Nota técnica Informativa

ACTUALIZACIÓN GUIAS DE ASIENTO SUPERCOPA

RACING SEAT BRACKET UPGRADING

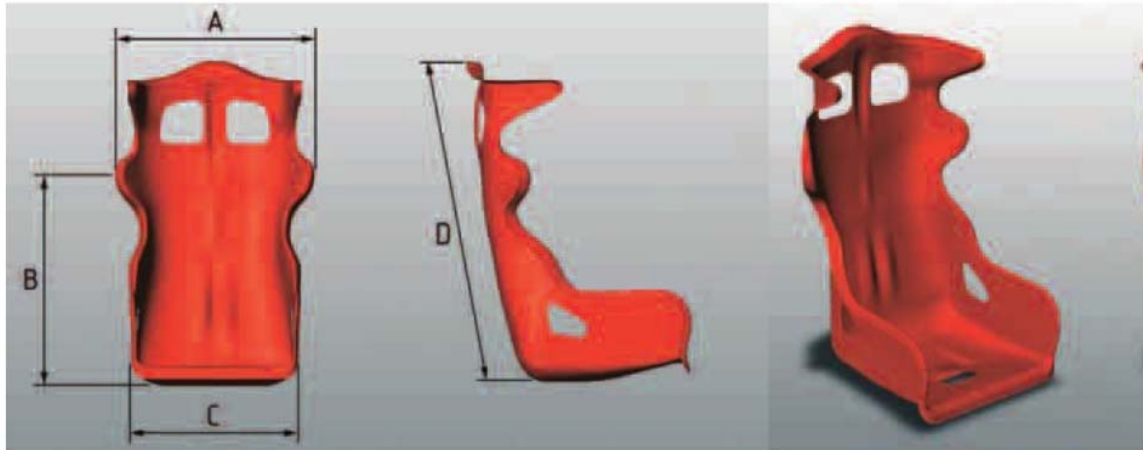
Por cambios en la producción del fabricante se cambiado de guía de asiento. A continuación se informa de las referencias de guías de asiento asociadas según referencia de asiento en el caso que se deba hacer un cambio.

VEHICULOS CON ASIENTO REFERENCIA: (coches anteriores Abril 2007)

Ref. OMP: **HA / 718 / N** (ver etiqueta asiento)

Ref. SEAT: **V4PL881019**

C= 470 mm.

Ahora se monta con las siguientes referencias:

Referencias SEAT: **soporte V4PL881689A (x1)**
+ arandela V131420045 (x4)
+ tornillo VN0001906739 (x4) (M8x30)

VEHICULOS CON ASIENTO REFERENCIA: (posterior Abril 2007)

Ref. OMP: **HA / 743 / N** (ver etiqueta asiento)

Ref. SEAT: **V4PL881019A**

C= 500 mm

Se monta la guia:

Ref. SEAT: **soporte V4PL881689A (x1)**
